Document
Design & Access Statement Addendum

Project
Sunte House The Farmyard & The Barn

Sunte House: Full Planning Application DM/25/1708; DM/25/1709 Design and Access Statement Addendum December 2025

Farmyard Revised Rooflights

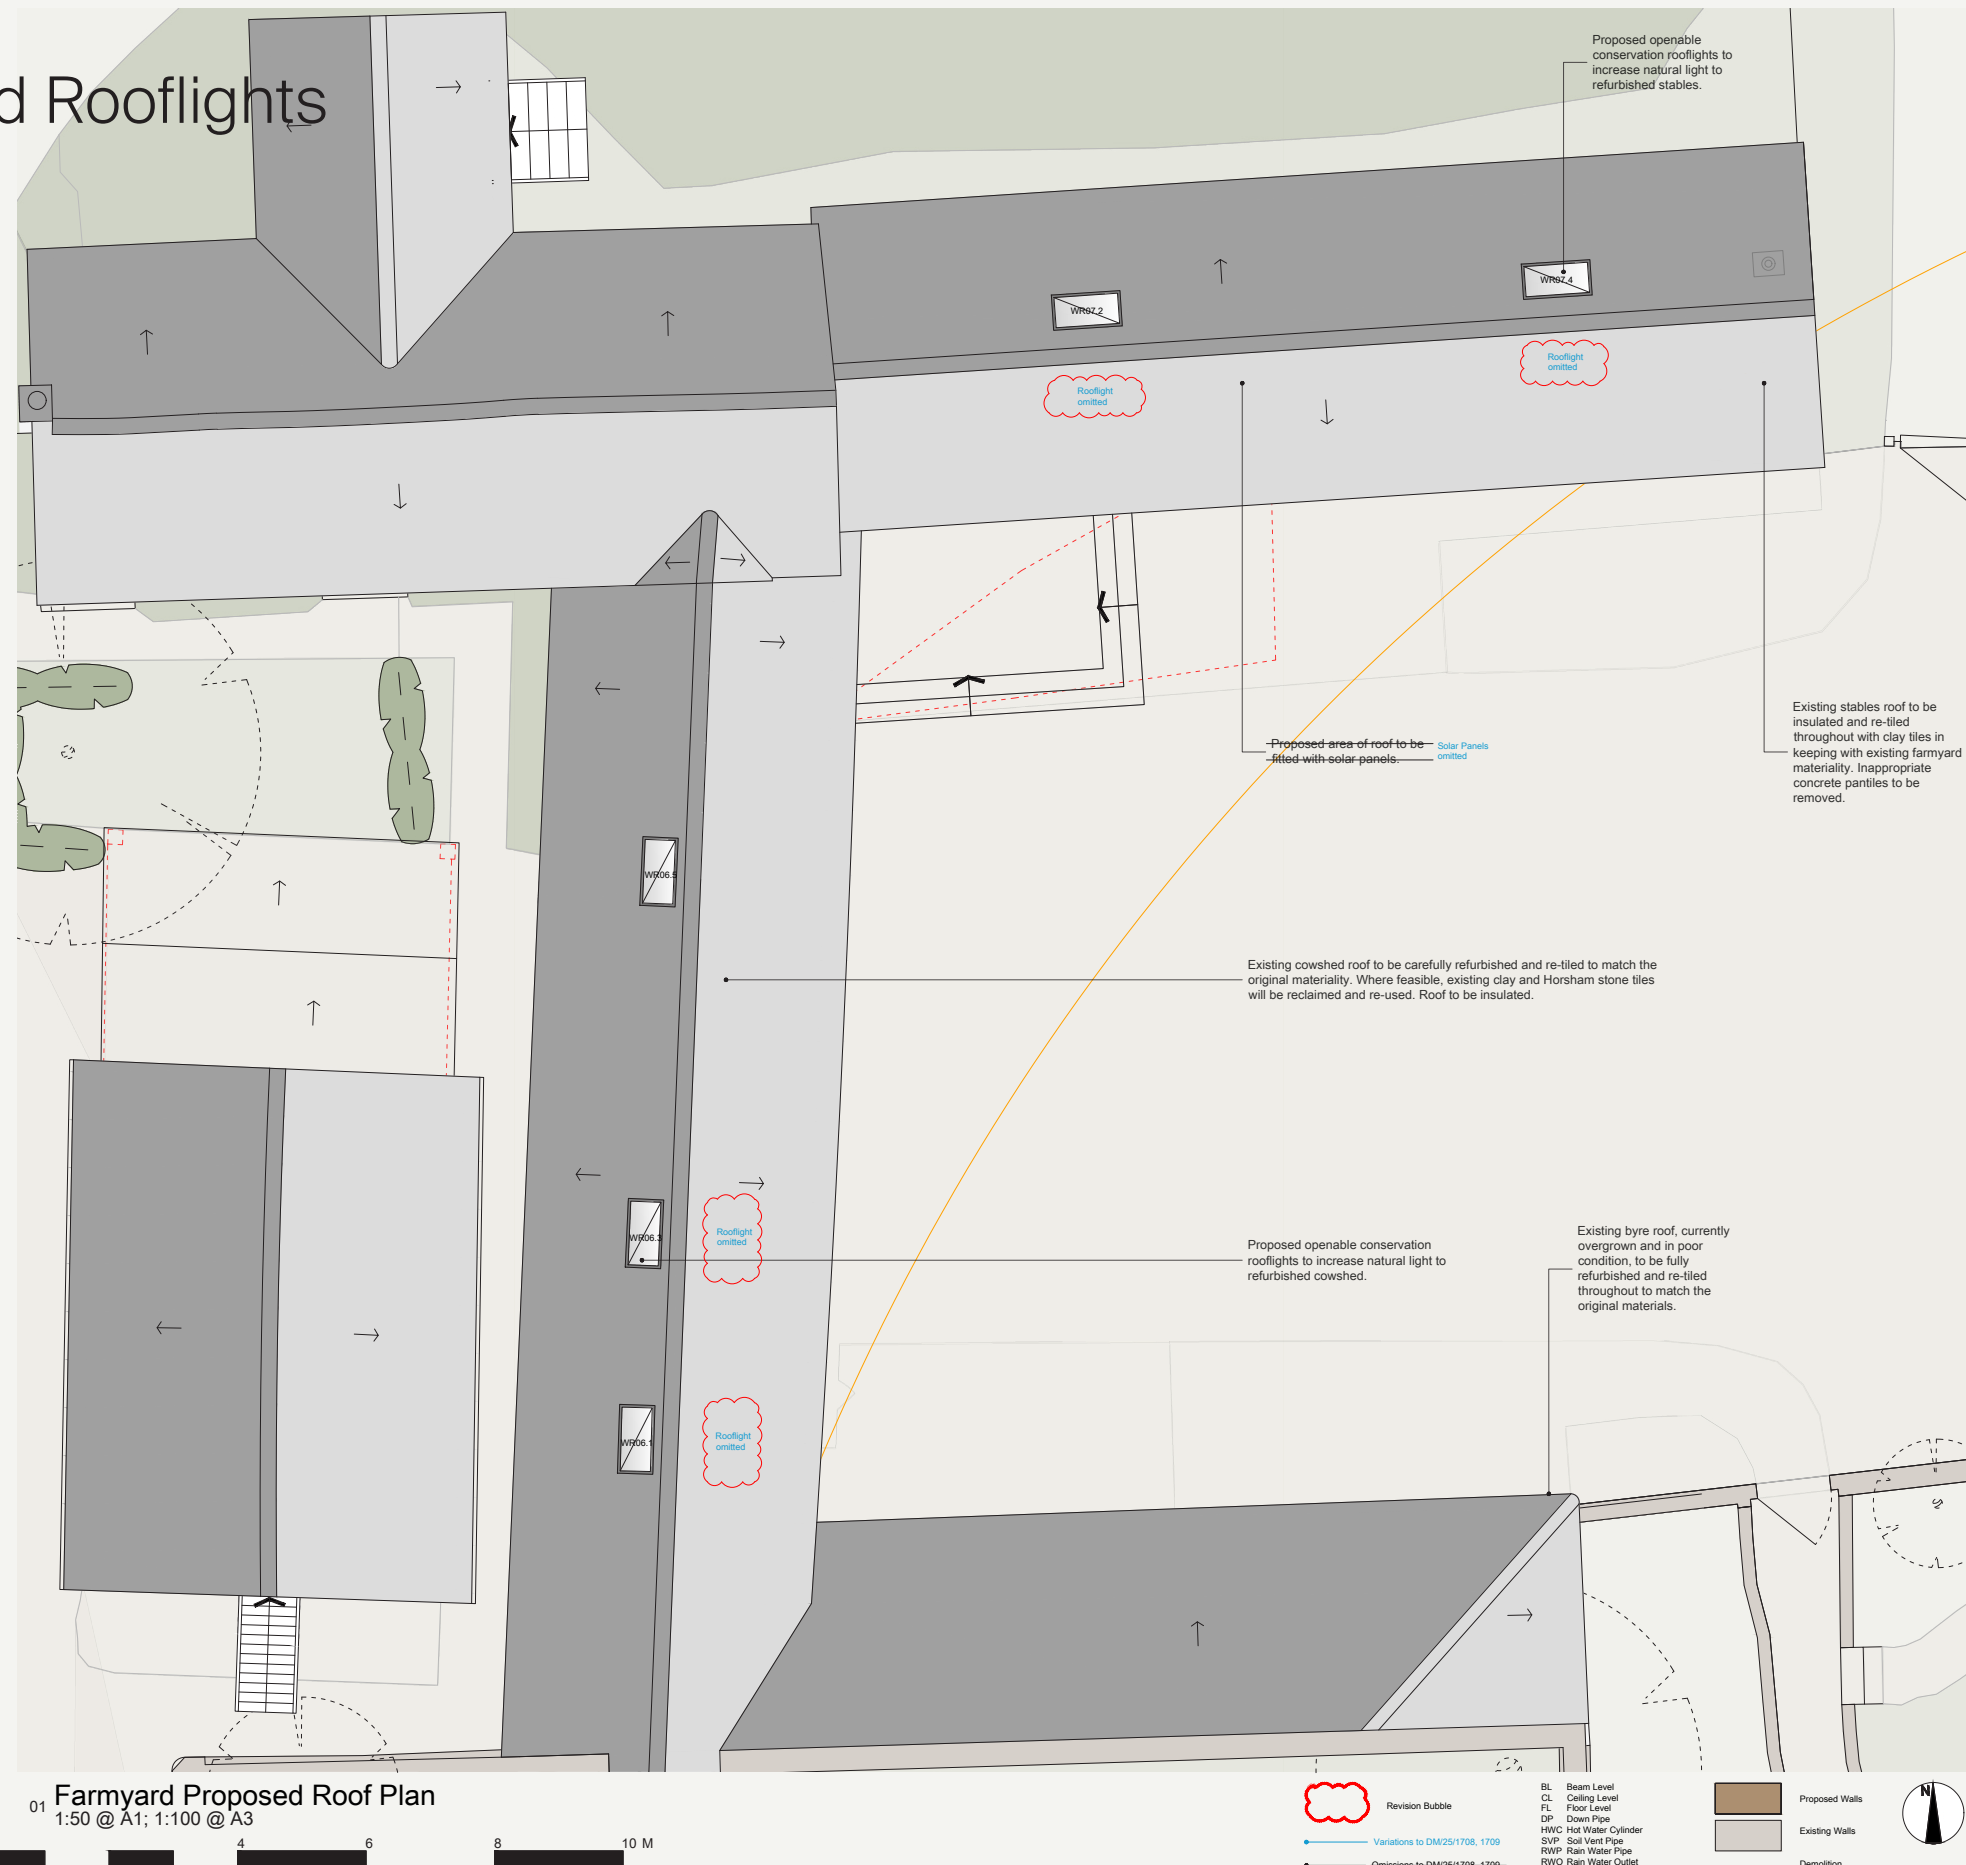
- Remove rooflights to reduce “harm” to agricultural character of farmyard roofs where possible

- The roof lights proposed to the southern roof slope of the stables and eastern roof slope of the cowshed (visible from the farmyard) WR06.2, WR06.4, WR07.1, WR07.3 have been removed from the proposals

ORIGINAL SKETCH SUBMITTED WITH FULL PLANNING APPLICATION DM/25/1709

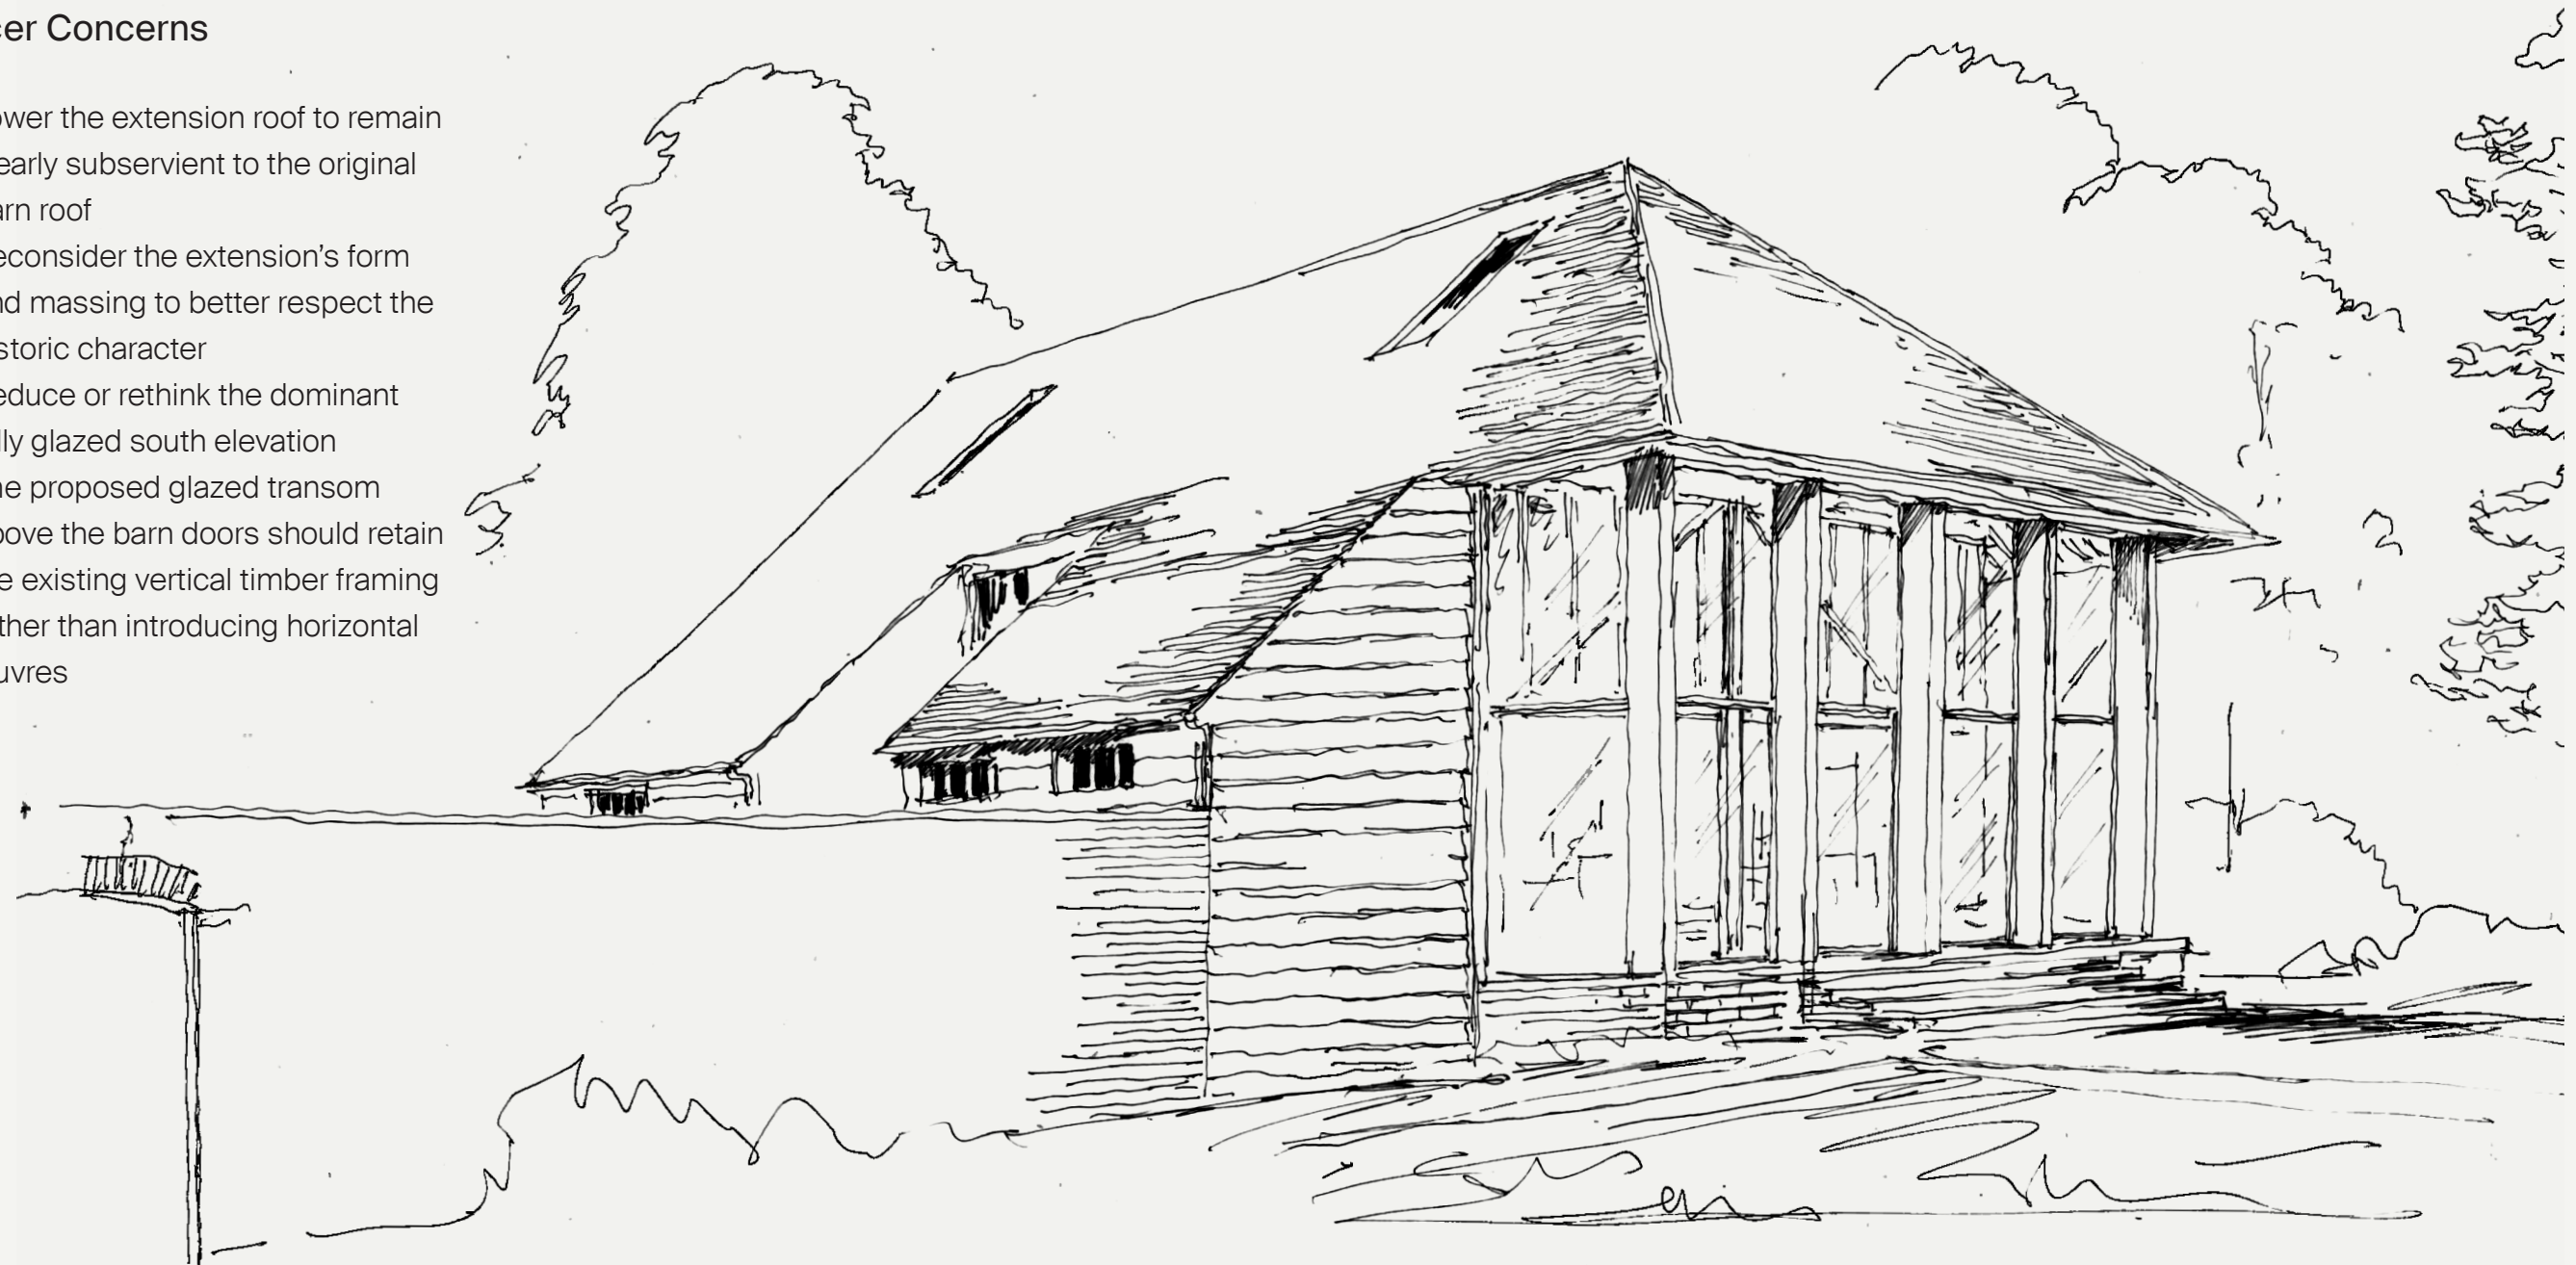
- Lower the extension roof to remain clearly subservient to the original barn roof
- Reconsider the extension's form and massing to better respect the historic character
- Reduce or rethink the dominant fully glazed south elevation
- The proposed glazed transom above the barn doors should retain the existing vertical timber framing rather than introducing horizontal louvres

PROPOSED WEST ELEVATION WITH REVISED GLAZING APPROACH

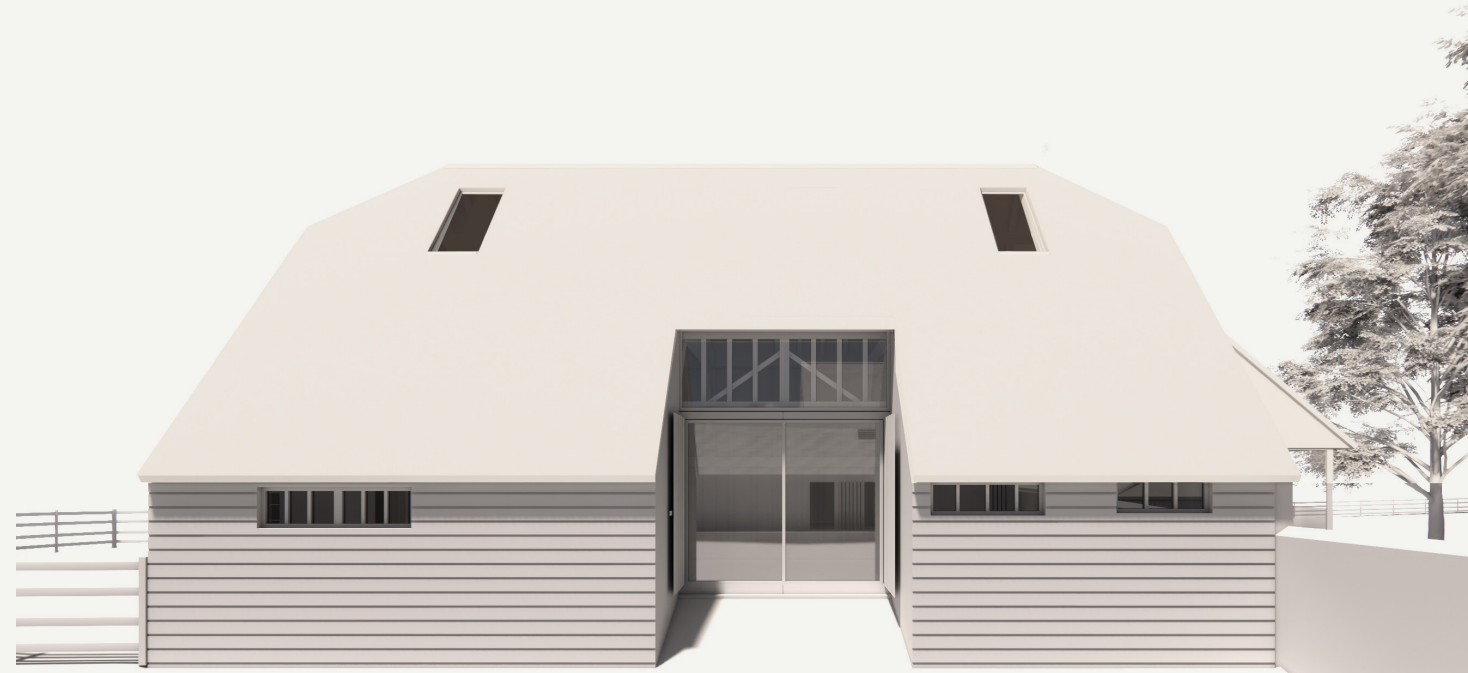
1. Avoid the proposed horizontal subdivision
2. Query of 2 instances of door openings to access under catslide

1. Remove horizontal louvres externally to expose existing timber structure visible through newly proposed glazing above transom
2. Visual clarification - internally existing blockwork fabric is present at the location of new openings to access under catslide
